Case 17zone1049L

We are concerned about the hazards of the proposed entrances to the new facility at the corner of Bardstown Road and Watterson trail.

# ENTIRANCES AND PROBLEMS:

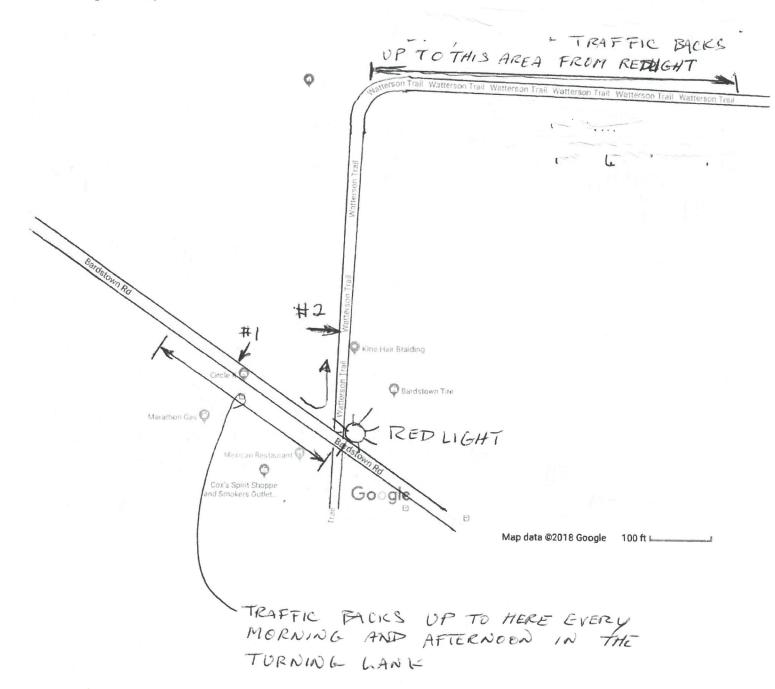
There is a lot of traffic that backs up from the Redlight all the way around the corner on Watterson Trail in front of my house every day. If someone trys to cross that line of cars to get into the proposed entrance, it will cause traffic to back up through the redlight causing grid lock. No one will be able to let them cross through because it doesn't move until that redlight changeswhich only lets through a few cars at a time.

If they are coming from the south bound turning lane onto Watterson trail, it will be worse. A long "train" of cars goes through that light when it changes. It will back up through the light and stop the north bound Btown road flow. People are impatient at that light because it takes a long time to change. a lot of people run it even as its turning red. When that happens, it will stick out into the main intersection.

- # | PEOPLE HAVE WRECKS TRY ING TO GET ACCROSS THIS LAKE
- #2 IF SOMEONE WANTS TO ENTER THIS ENTRANCE,
  THE THRNING TRAFFIC OFF OF B-TOWN RD
  ONTO WATTER SON TRAIL WILL CAUSE A BACK OF
  THROUGH THE LIGHT, AND RESULT IN GRIDLOCK
